From: Anderson, Richard
Sent: Friday, August 14, 2015 10:00 AM
To: 'traver.jones@kimley-horn.com'; Steve.Haney@kimley-horn.com
Cc: Couch, Ashley; Clack, Michael; Grant, Randy; Murillo, Jesus; Venker, Steve; rorme@mark-taylor.com
Subject: FW: Mark-Taylor Silverstone Updated Drainage
Attachments: 2015-08-06 UG Storage Exhibit.pdf; 2015-08-07 Delineation Map.pdf; 2015-08-07 Grading and Drainage Plan.pdf; 2015-08-07 Storm Drain and Wall Plan.pdf; Stormwater Detention-Calculations-2015-08-05.pdf; City of Scottsdale - Underground Stormwater Storage Policy.pdf

UNDERGROUND
DETENTION
EXHIBIT

Case Drainage Report Review – Mark Taylor Silverstone - Parcel E

PROJECT NAME: MARK TAYLOR SILVERSTONE – PARCEL E OF SILVERSTONE
LOCATION: SOUTHEAST CORNER OF SILVERSTONE DRIVE AND SCOTTSDALE ROAD
CASE NUMBERS: 53-DR-2014

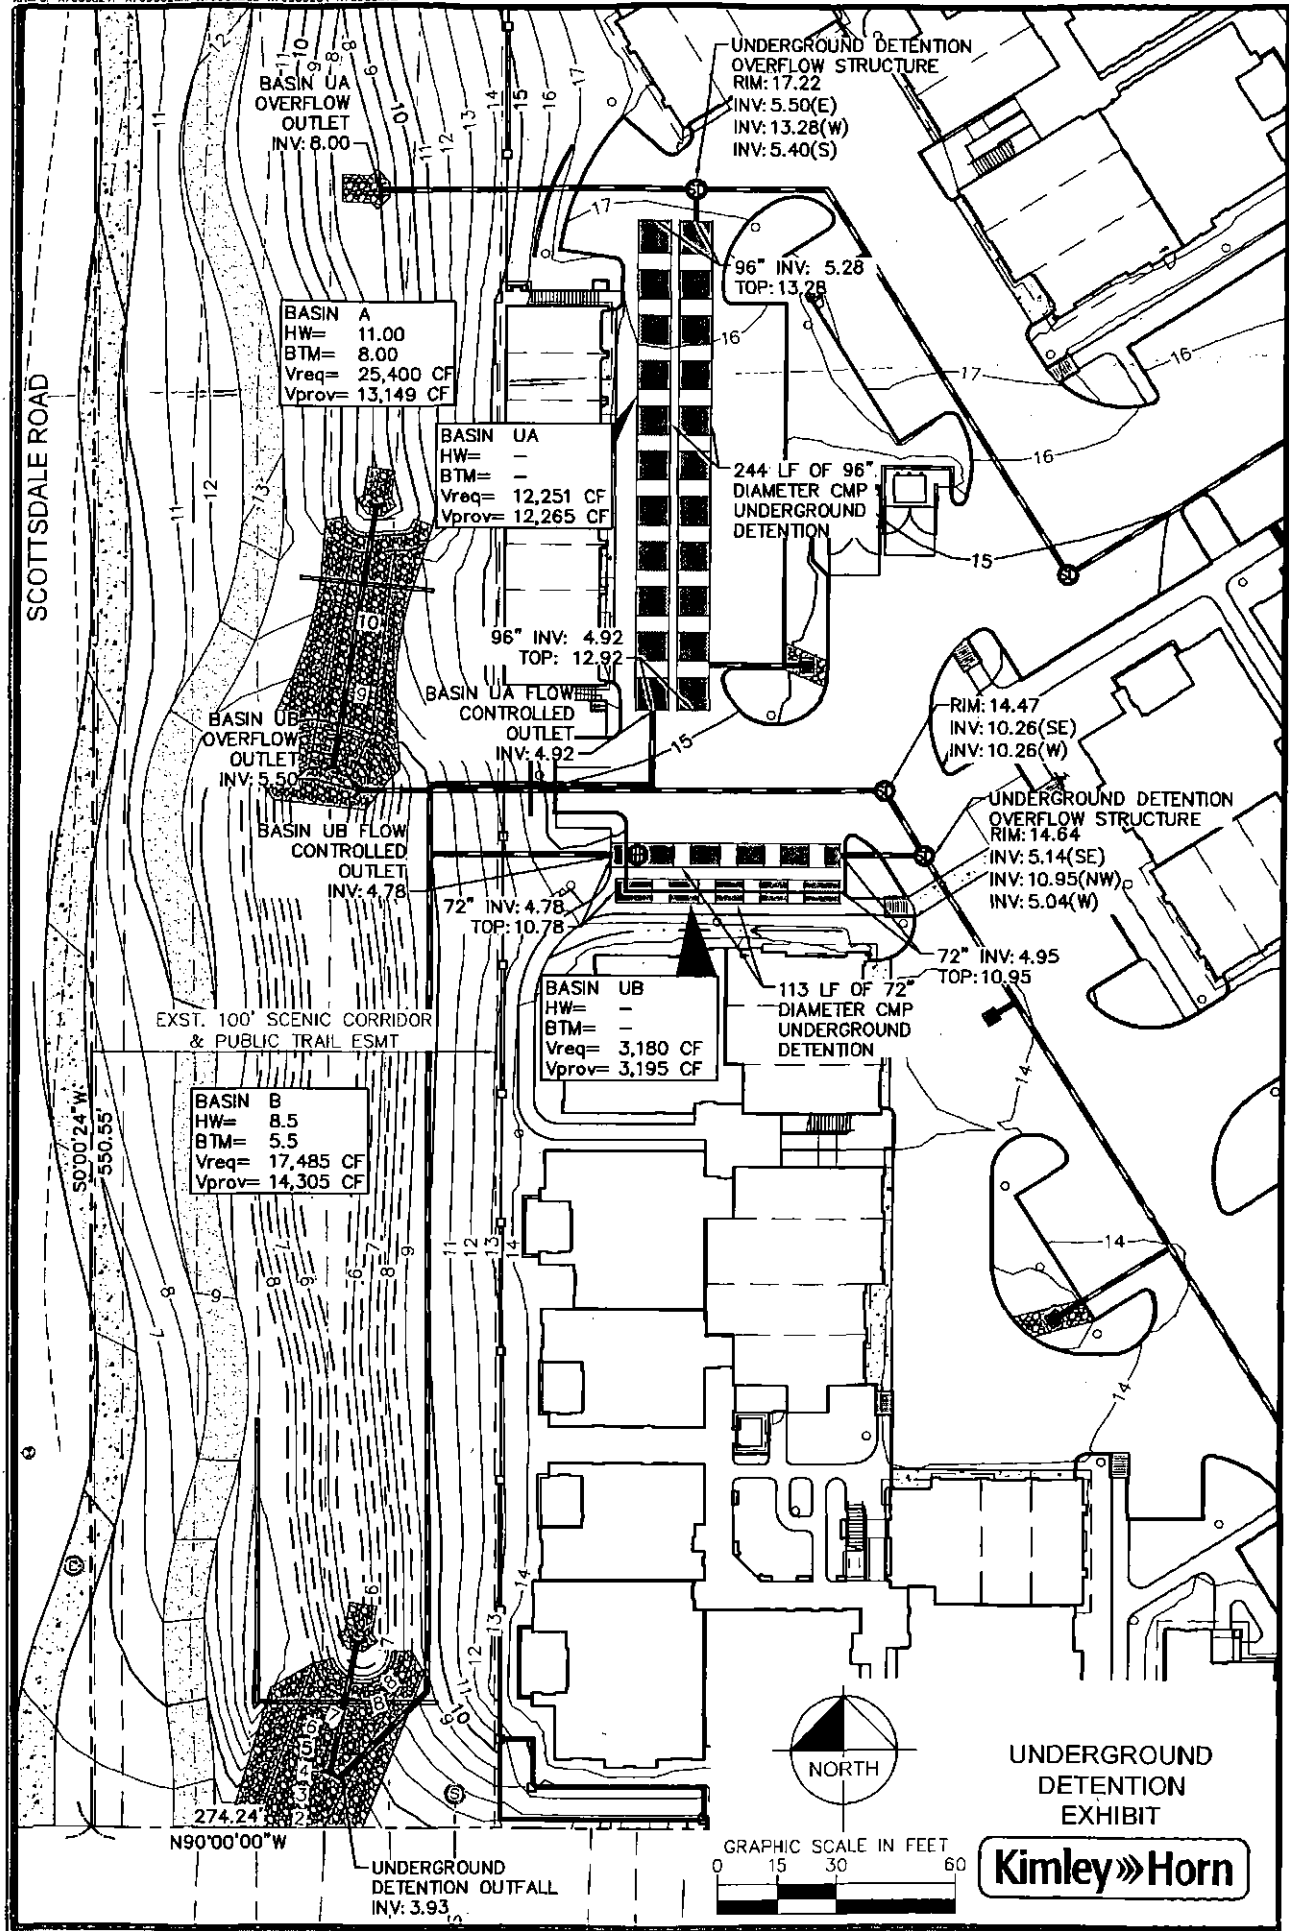
Thanks for taking the time to meet with us to discuss the Silverstone project on Wednesday. As discussed, we've reduced the surface detention area within the scenic corridor area to approximately 25% and provided underground detention for the displaced volume. I've attached a few exhibits and some calculations, and the "2015-08-06 UG Storage Exhibit" is intended to provide you with an overview of our design for the revised system.

As you can see, we are providing underground detention in 6' and 8' diameter tanks, and these tanks can bleed off at a controlled rate to the channel outfall. We're providing overflow structures immediately upstream of each of the underground tanks. These structures will ensure that the underground detention fills first, and then once the tanks are full the storm water will bypass the tanks and discharge to the surface basins.

Could you please review the revised drainage concept and let me know if you find this to be sufficient? Feel free to contact me if you have any questions or concerns, or if you need any additional information. Thanks,

I have reviewed the revised stormwater storage design and analysis provided in the below e-mail for the use of partial underground stormwater storage and found it to be acceptable. The information in the below e-mail will be considered a revision to previously approved preliminary grading and drainage plan and drainage report with respect to the revised design and analysis presented.

The stipulations for the case will include verbage relating to the use of underground storage stating the storage will need to comply will the provisions of the City's underground storage policy as detailed in section 4-1.403 of the City's Design Standards and Policies Manual. A copy of the policy is attached.

PRELIMINARY GRADING & DRAINAGE PLAN

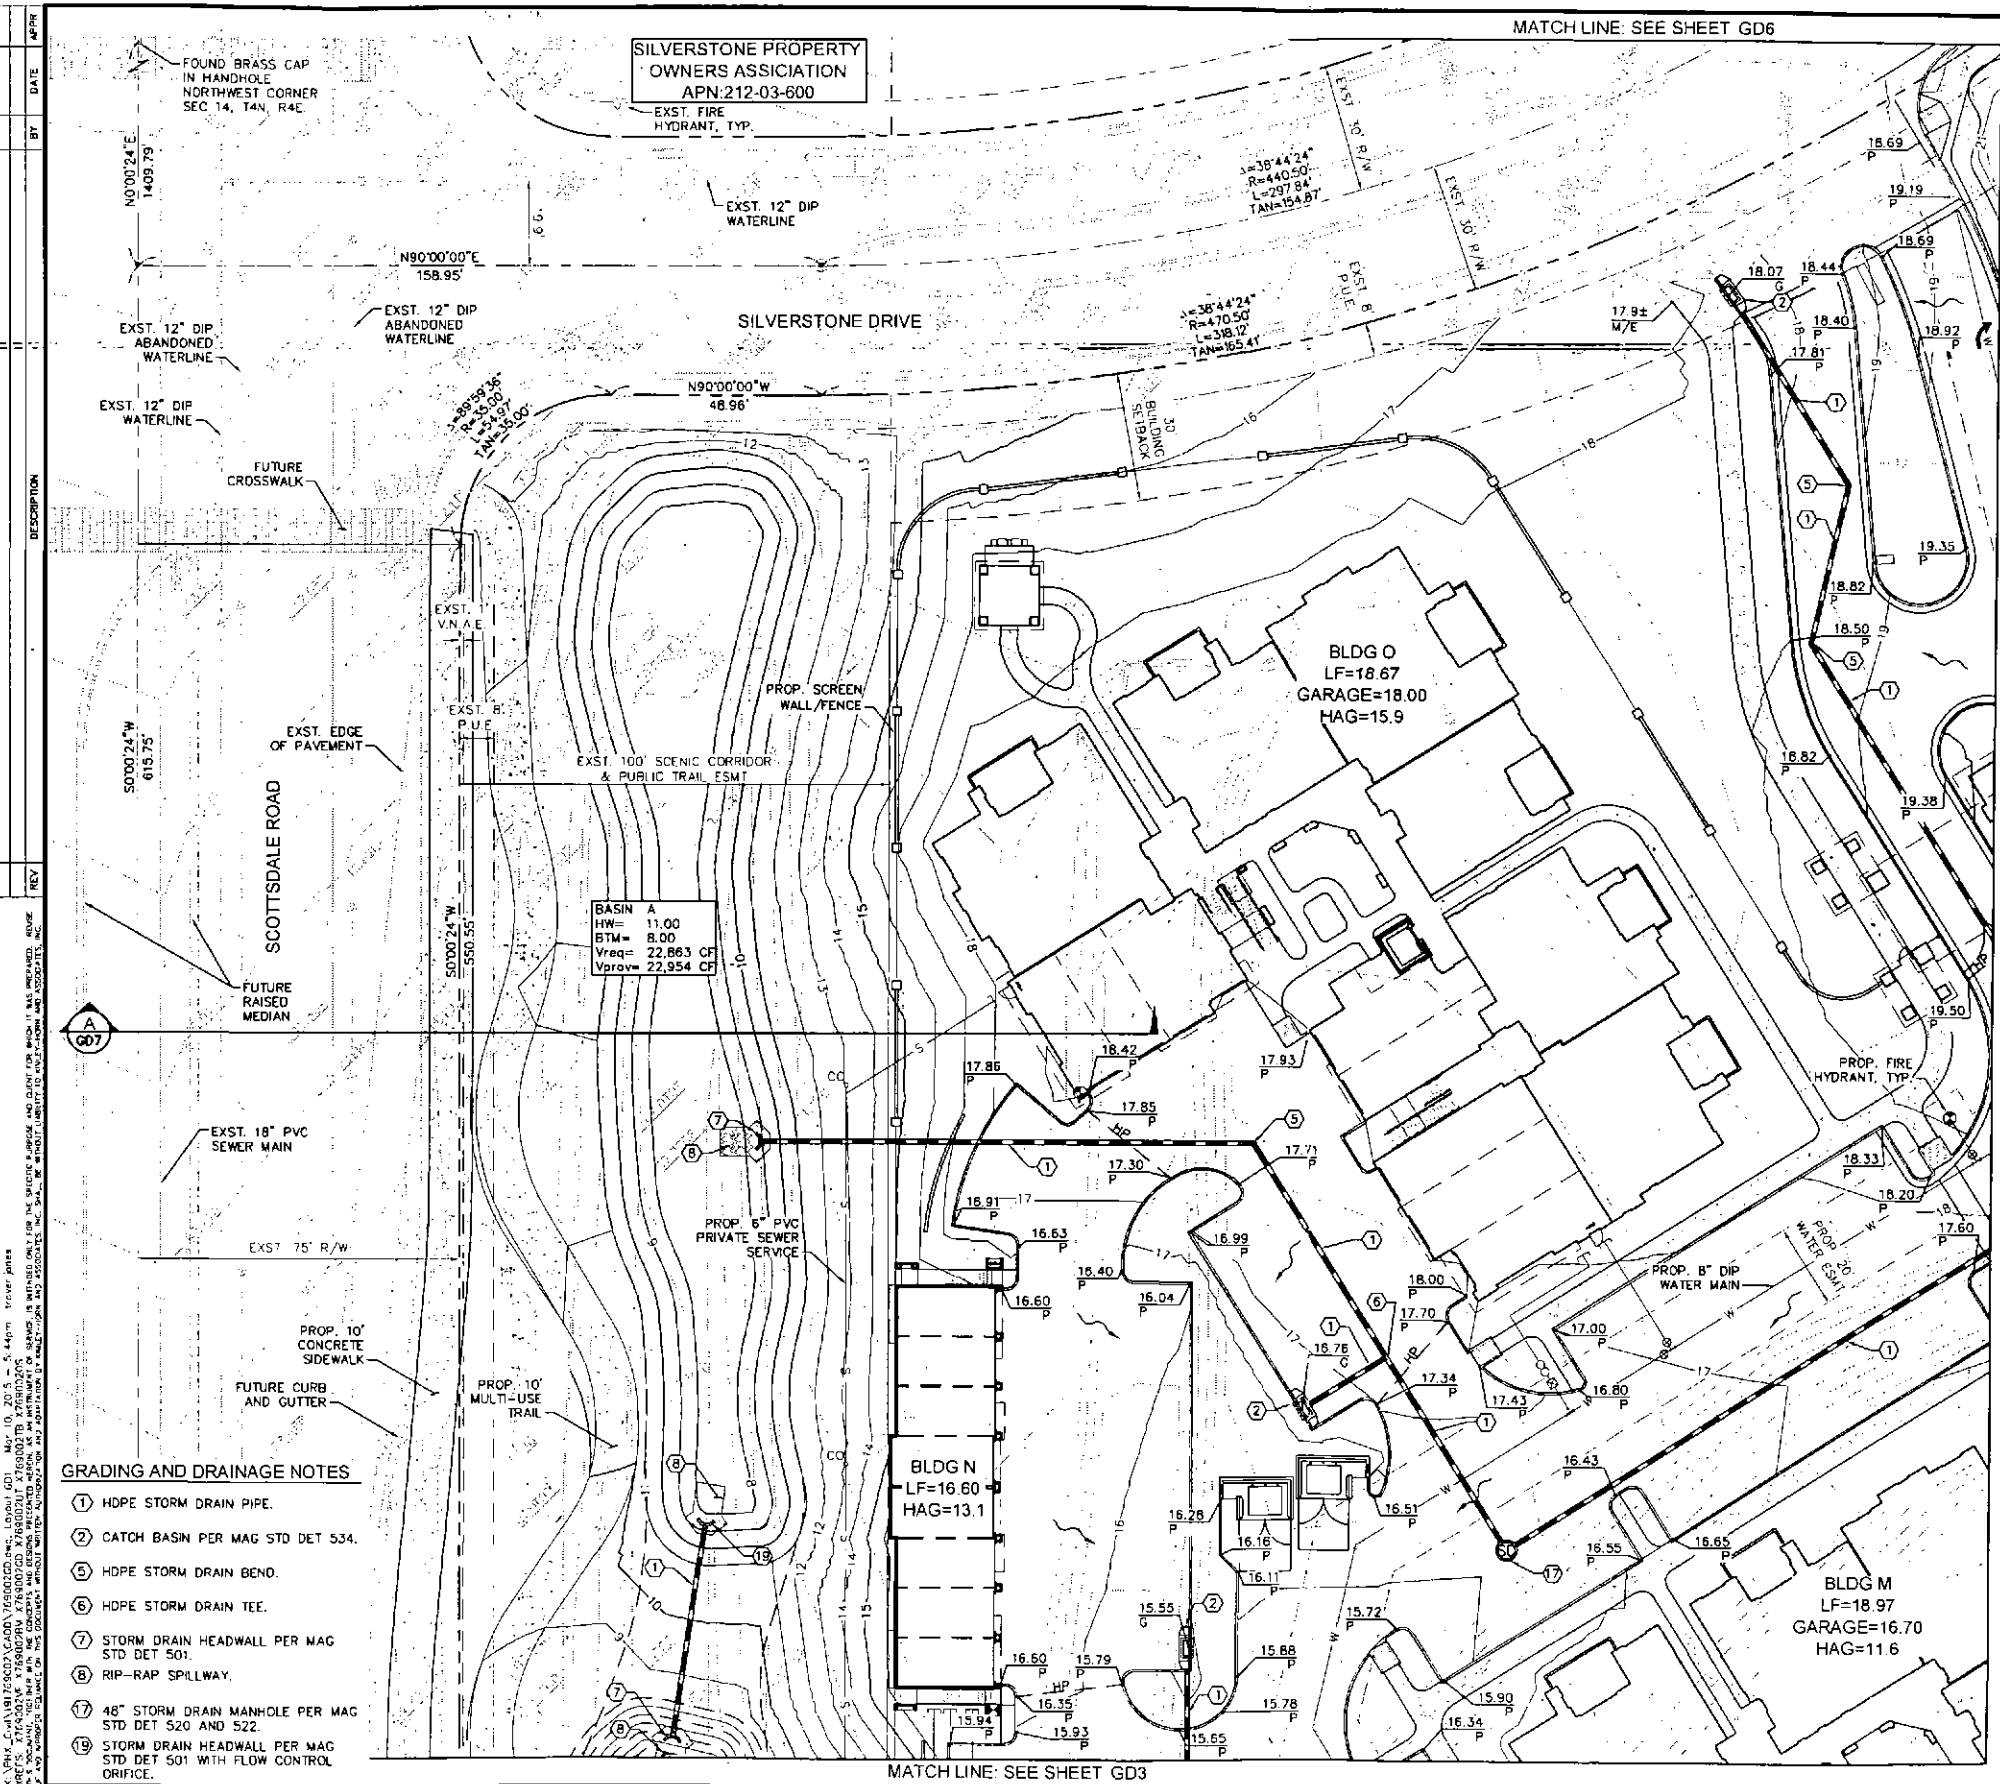
3. The approved stormwater master plan for Silverstone shows the bulk of this site draining to the east into what was supposed to be a stormwater storage basin designed for full storage located in the southeastern portion of the site and then draining into the storm drain outfall located at the southeast corner of the site. The approved stormwater master plan for Silverstone did not include provision for any drainage from this parcel to the parcel to the south in the developed condition. The preliminary drainage report shows almost the entire development draining to the west to proposed stormwater storage basins located along Scottsdale Road. The issue of draining the parcel inconsistent with the approved master plan should be evaluated as part of a revision to the approved stormwater master plan for Silverstone and submitted for City review and approval.

4. The City still has concerns about proposed improvements and grading located at the south end of the scenic corridor along Scottsdale Road and the ability of the future developer of parcel D to tie-in to these improvements. In short, provisions will need to be included in the design of the project to allow the future developer of parcel D to tie into the proposed storm drain outlet at an elevation that is consistent with the grading design proposed by this project. Additionally, the design of southern end of the southern stormwater storage basin includes a berm or levee that may be subject to failure.
